ITEM	1
MANAGER'S REPORT NO.	33
COUNCIL MEETING	1981 07 13

RE: PROPOSED CLOSURE OF A WATERCOURSE
SUBDIVISION REFERENCE #18/81

TO: MUNICIPAL MANAGER	PLANNING DEPARTMENT
FROM: APPROVING OFFICER	1981 JUNE 29
RE: SUBDIVISION REFERENCE #18/81 (D.L. 59, BLK. 9, PCL. 'B' (EX.PL. 9840) WATERCOURSE	PLAN 3795

S.D. REF. #18/81

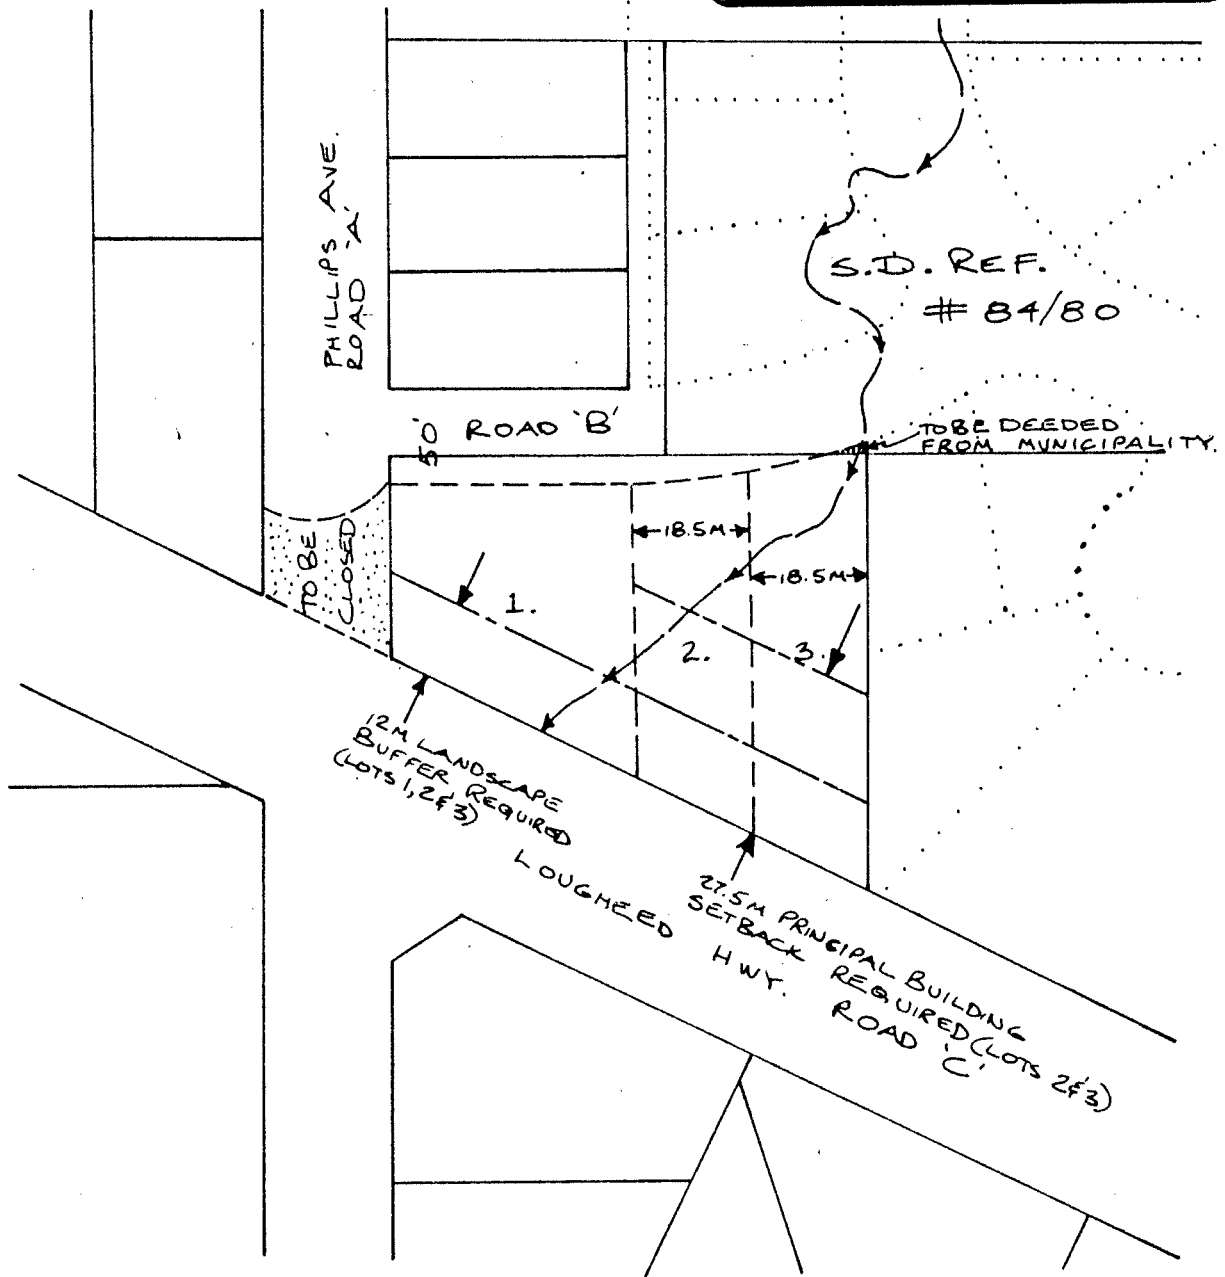
We are in receipt of an application to subdivide the subject property which is adjacent to the aforementioned subdivision as shown on the attached sketch.

A watercourse traverses the site which will restrict developable areas of the proposed lots. A site visit revealed that the watercourse is shallow, is approximately 1 m wide and is fairly well defined. The site area around the watercourse is well treed and undeveloped. Any aesthetic value and naturalness that the watercourse presently offers would be lost if it were relocated as most of the surrounding trees and vegetation would be destroyed in the process.

NOTE: ① SURVEYOR'S PLOT PLAN REQUIRED FOR EXISTING BUILDINGS ON PROPOSED LOT 1.

We therefore, have no alternative but to recommend that the watercourse be enclosed within the subdivision in a manner satisfactory to the Municipal Engineer.
